BYLAW C-7991-2020**A Bylaw of Rocky View County, in the Province of Alberta, to adopt the Ascension Conceptual Scheme**

SCHEDULE 'A'
FORMING PART OF BYLAW C-7991-2020

A Conceptual Scheme affecting Block 6, Plan 8710757, NE-18-25-2-W5M; Block A, Plan 9212196, SE-19-25-2-W5M; a portion of SE-19-25-2-W5M; and SW-19-25-2-W5M, herein referred to as the Ascension Conceptual Scheme.

Figure 12 - Boundary Interfaces

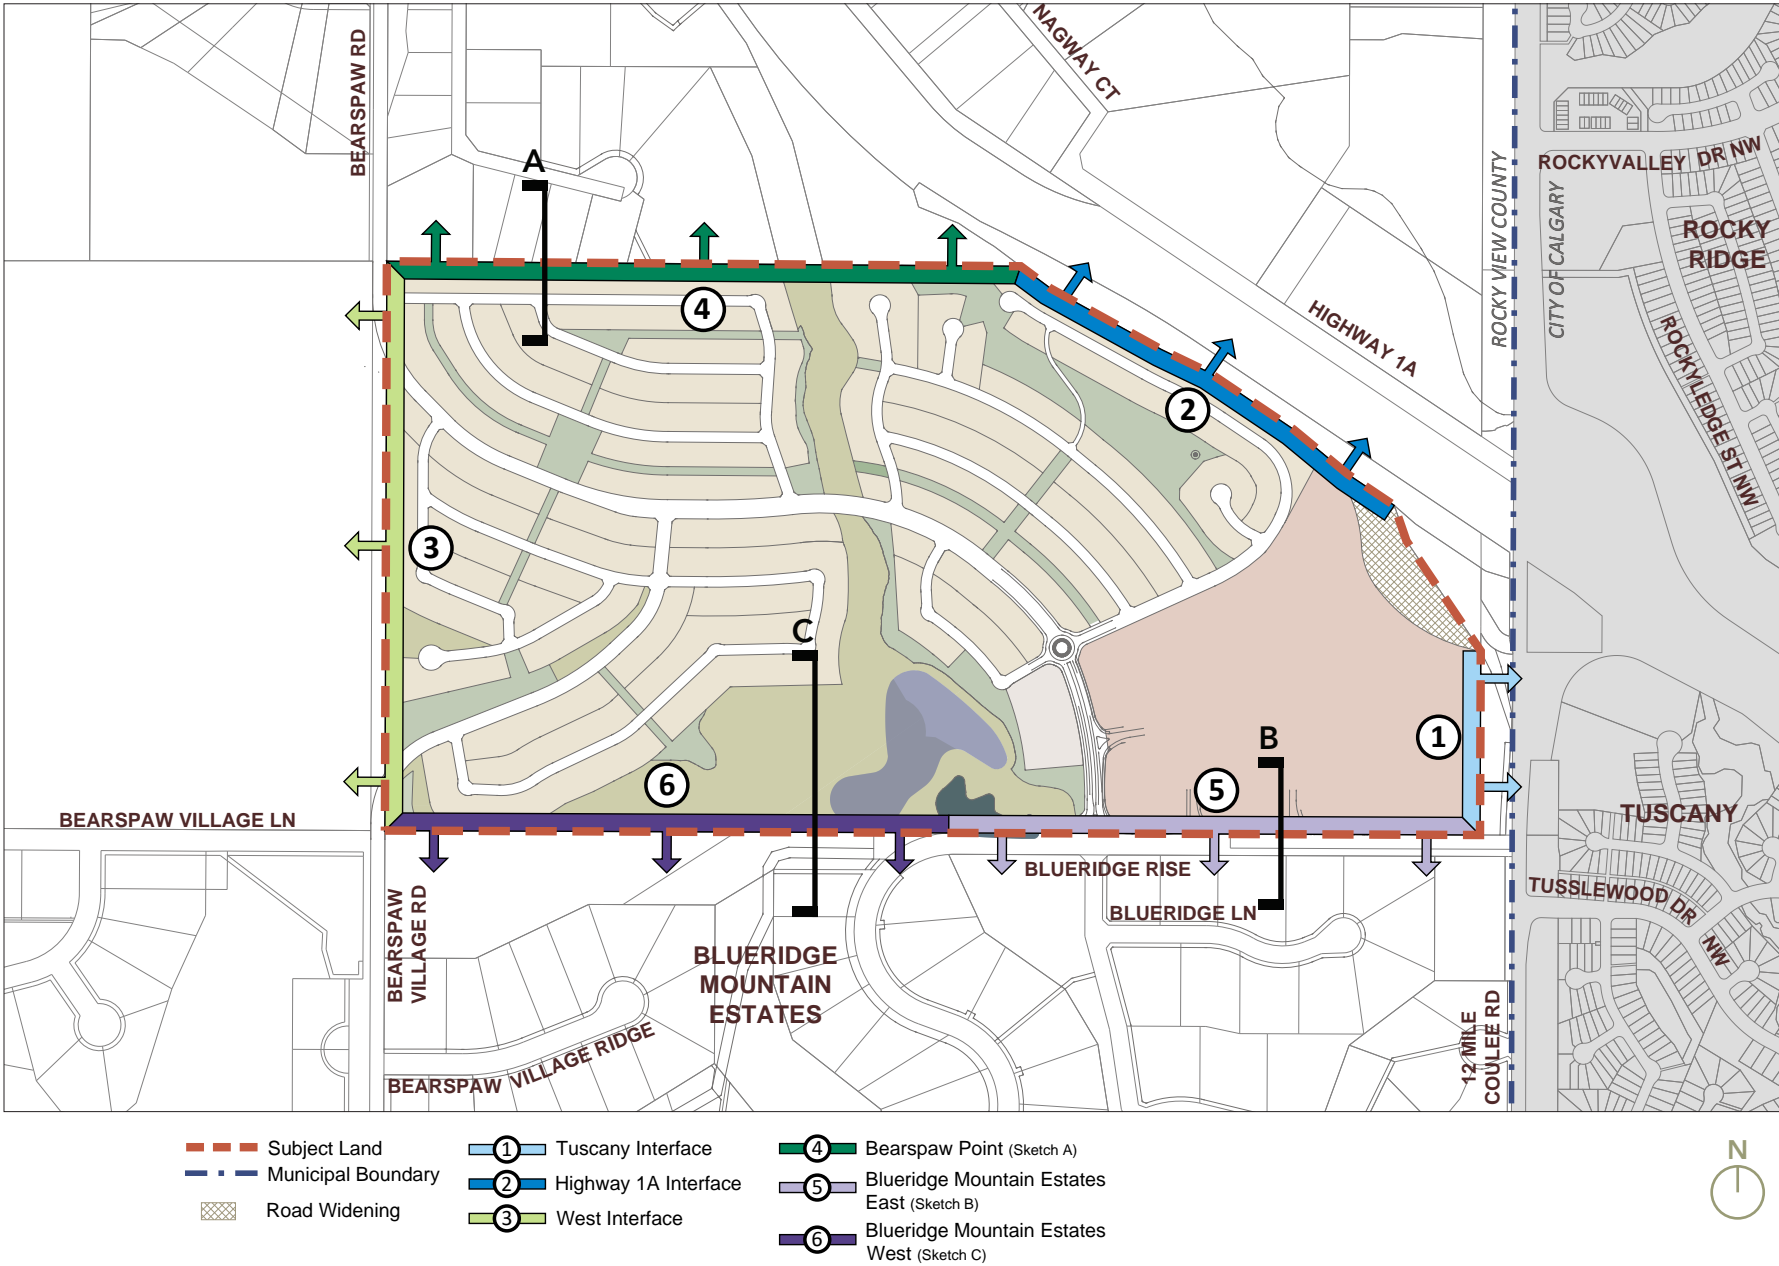
Figure was updated

Figure 13 - Regional Transportation Plan

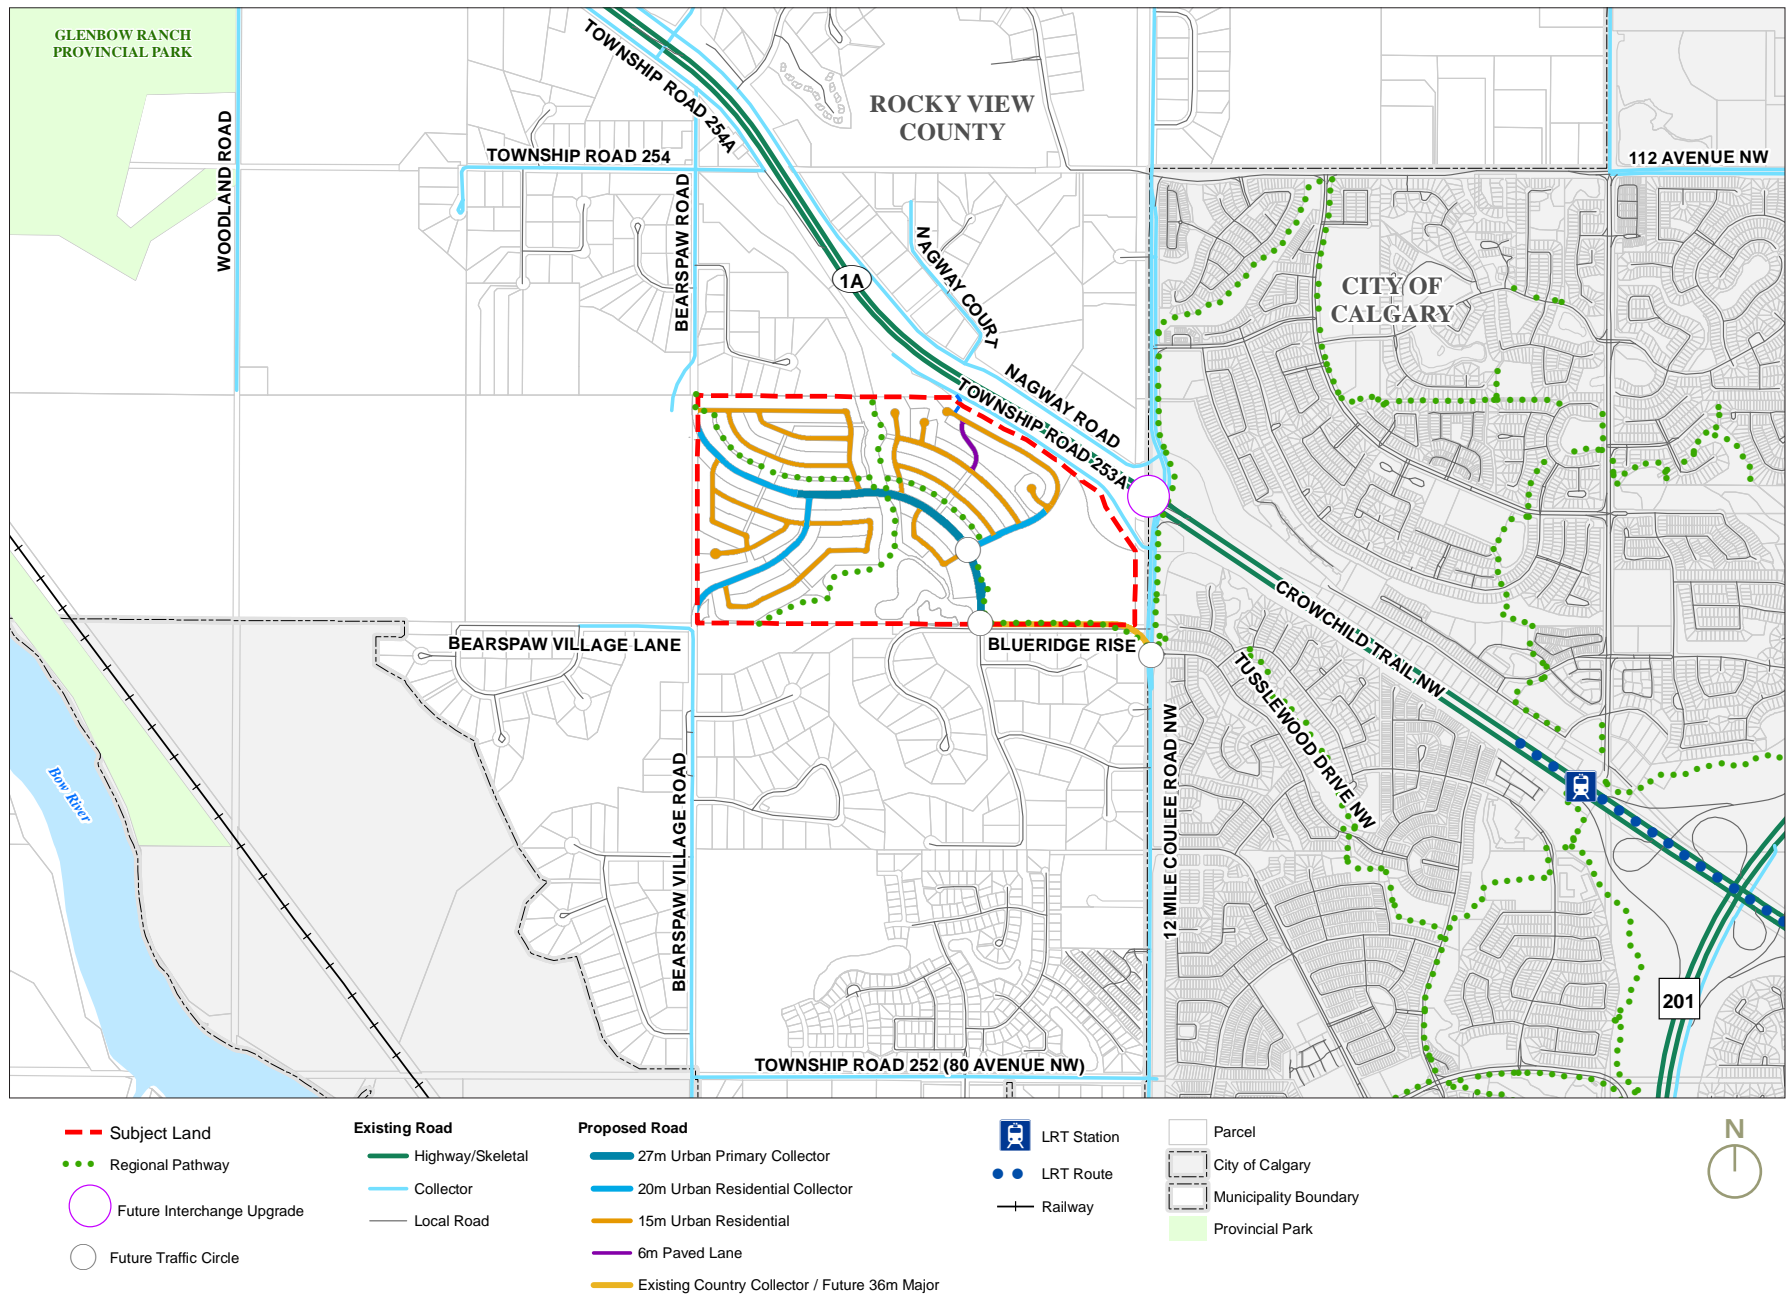
Figure was updated

Figure 14 - Internal Transportation Plan

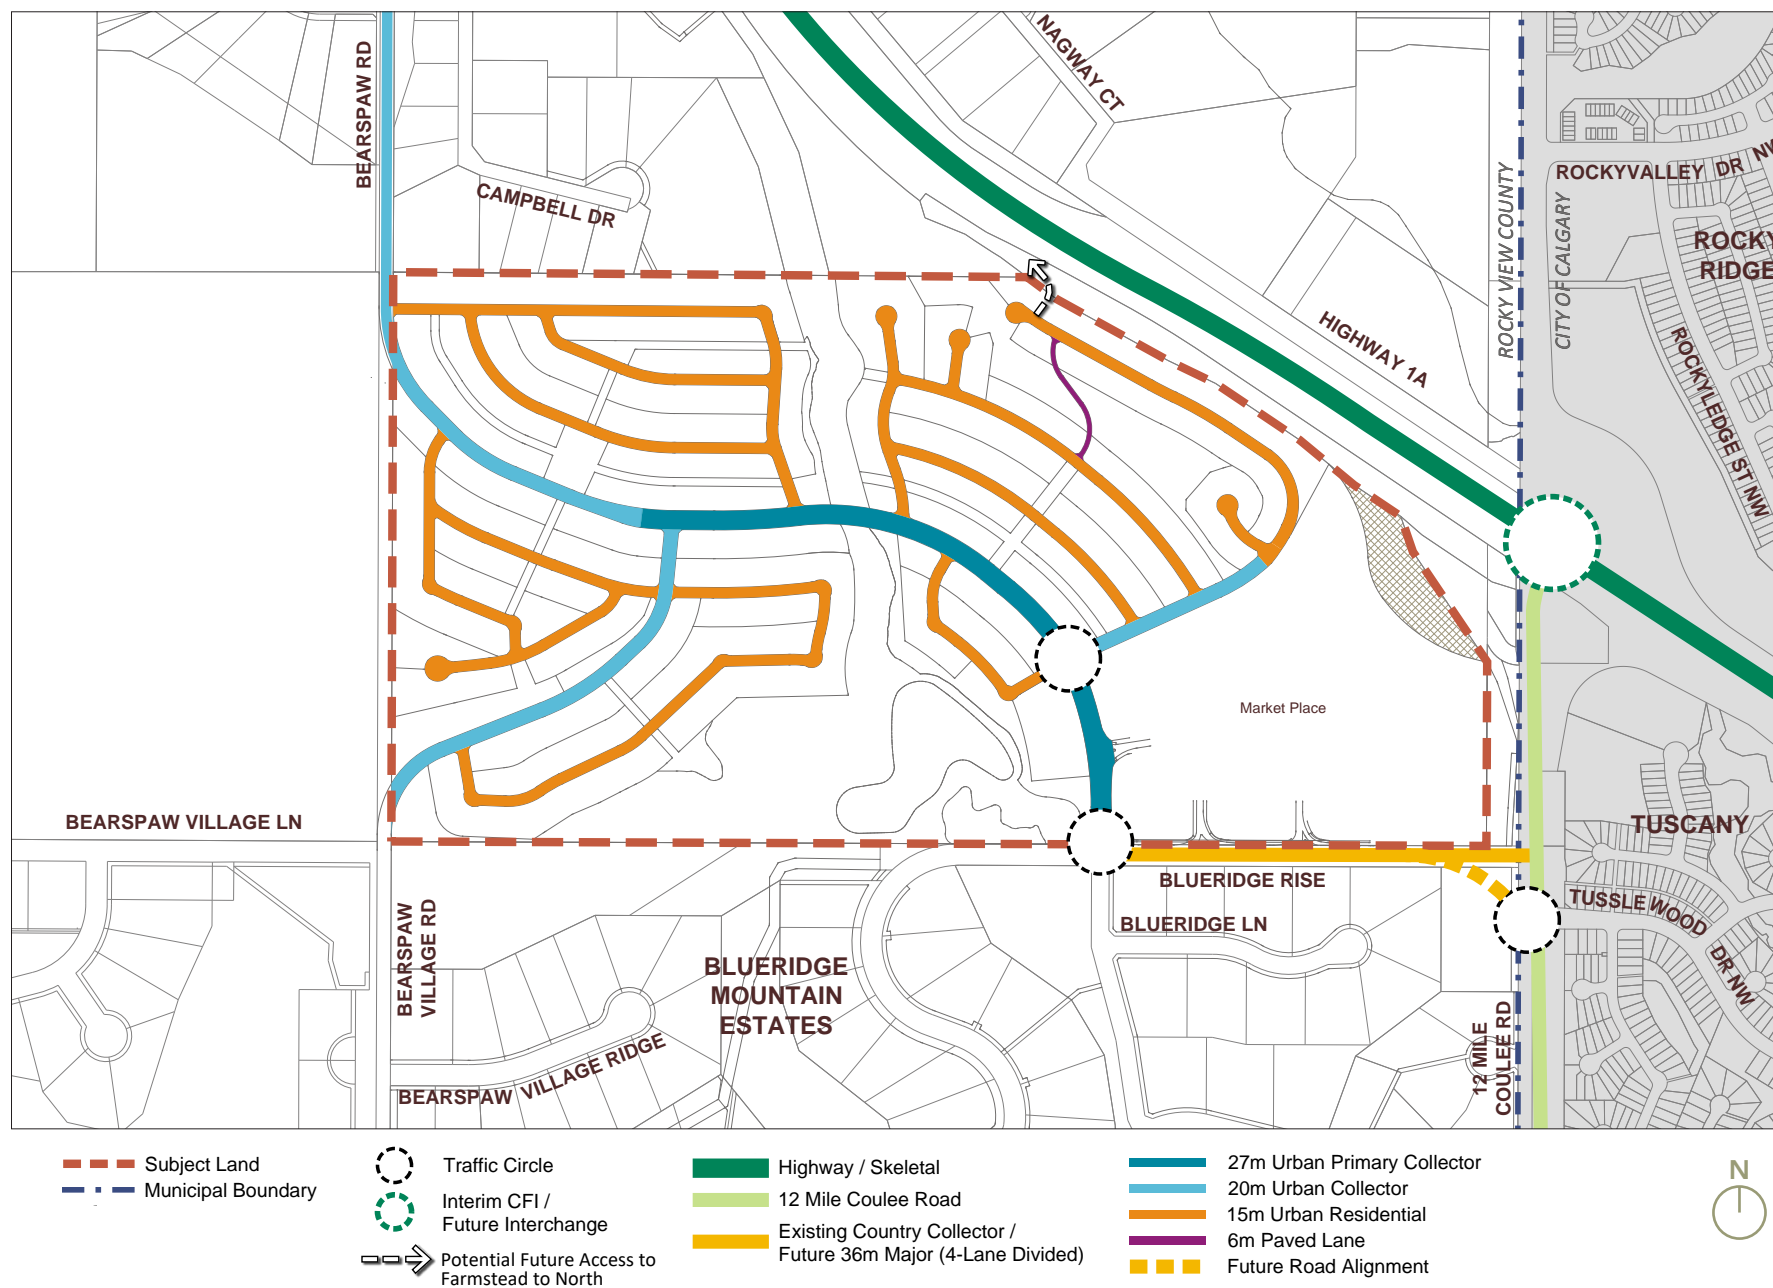
Figure was updated

The development contains ~~four~~**three** different road designs as illustrated on **Figure 14 – Internal Transportation Plan**.

Figure 15 - 27m Urban Primary Collector

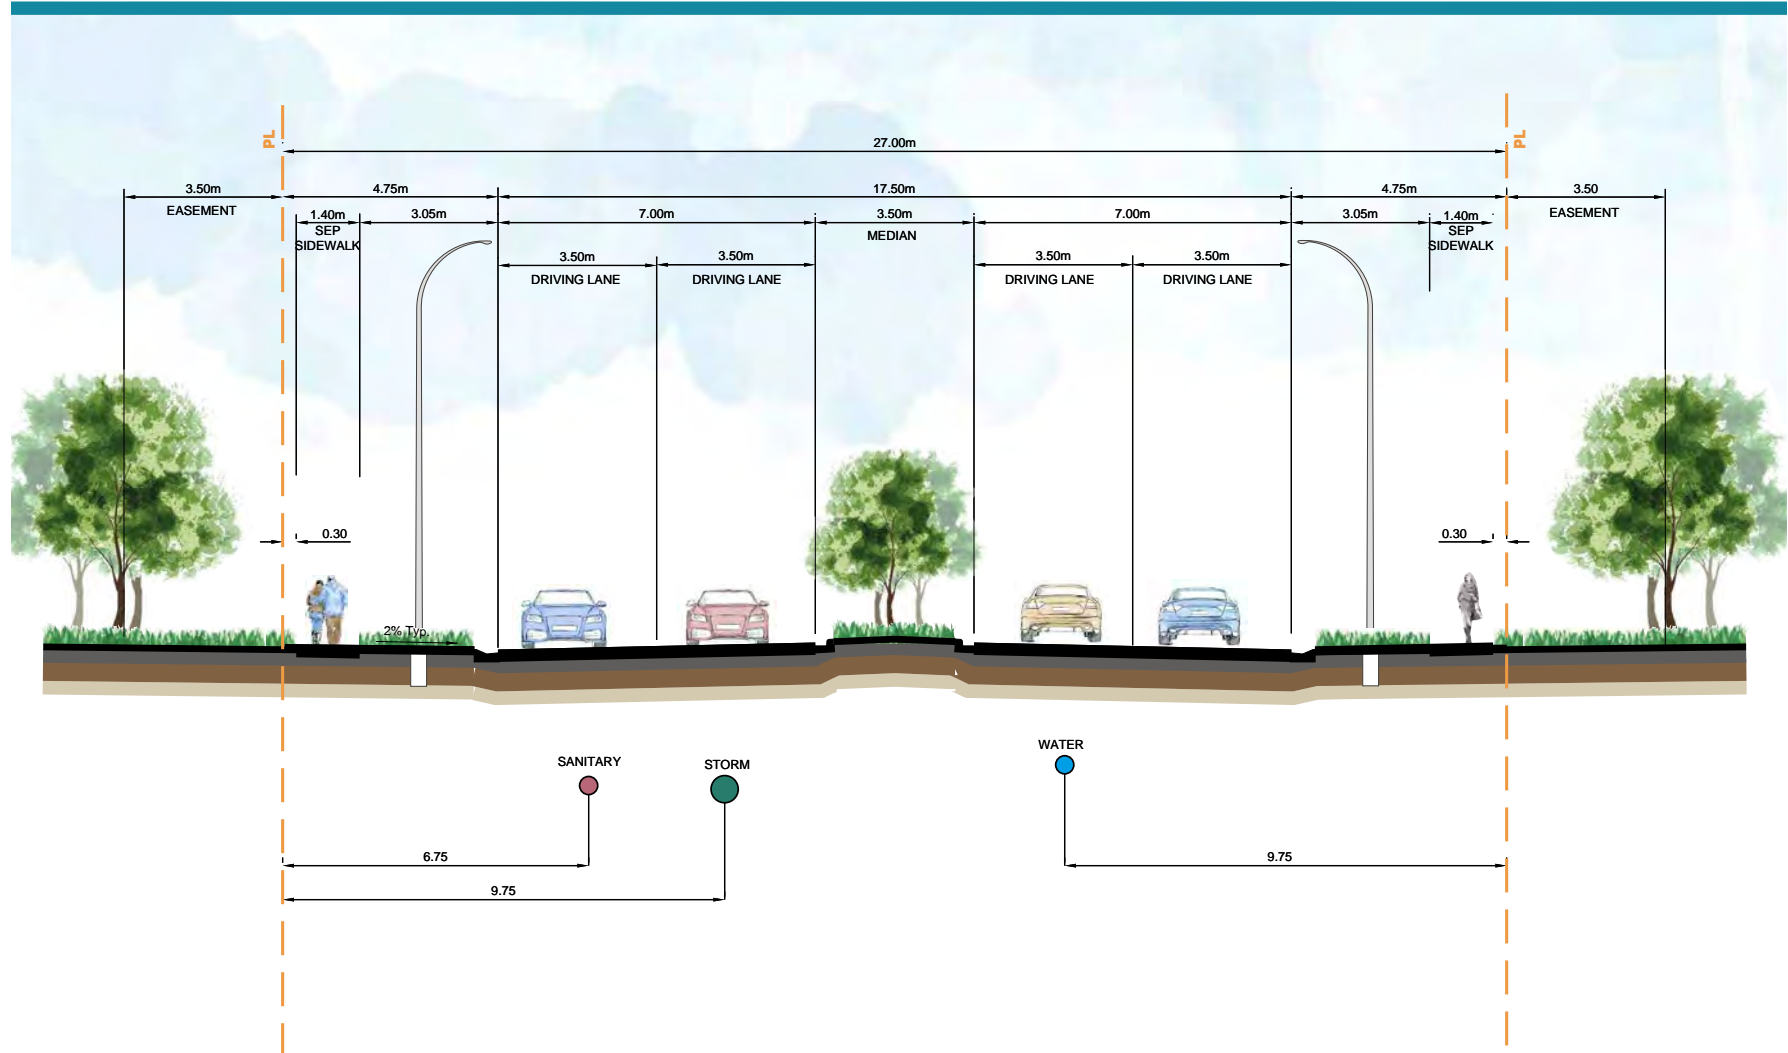
Figure was updated, Formerly "Grand Boulevard Road Design"

Figure 16 - 20m Urban Residential Collector

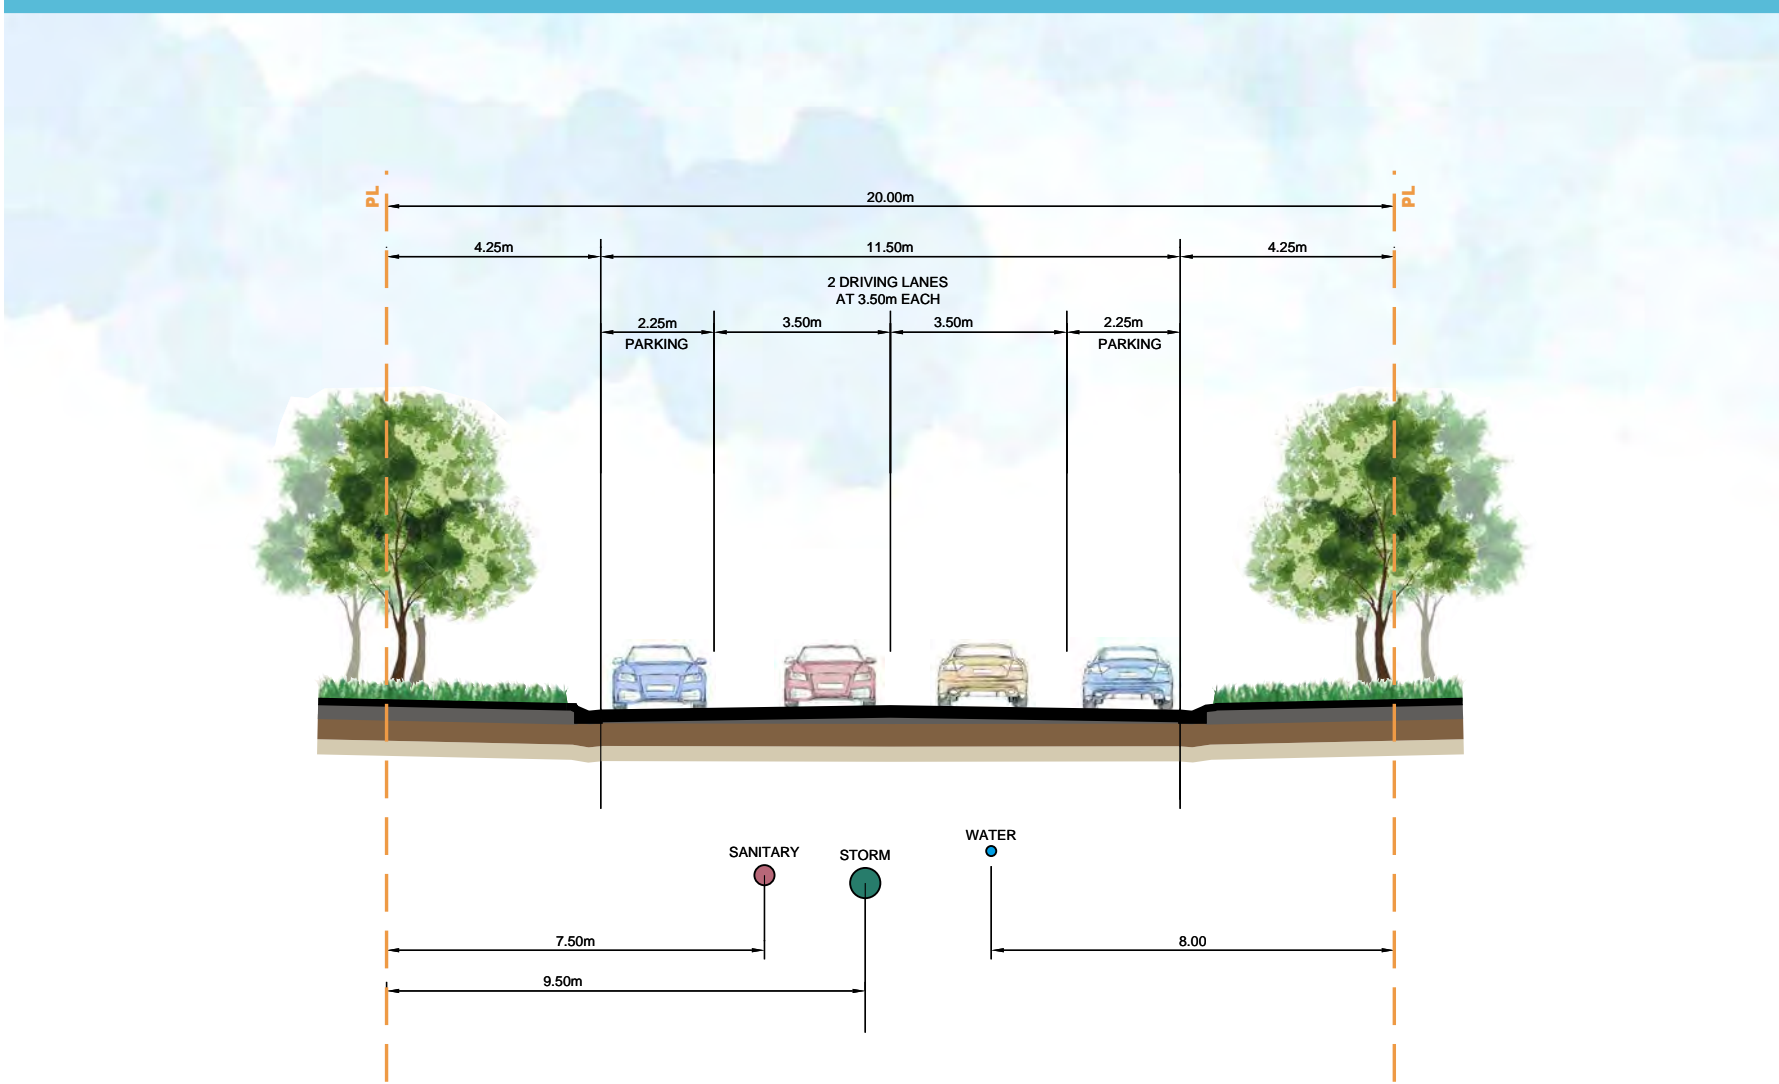
Figure was updated, Formerly "Collector Road Design"
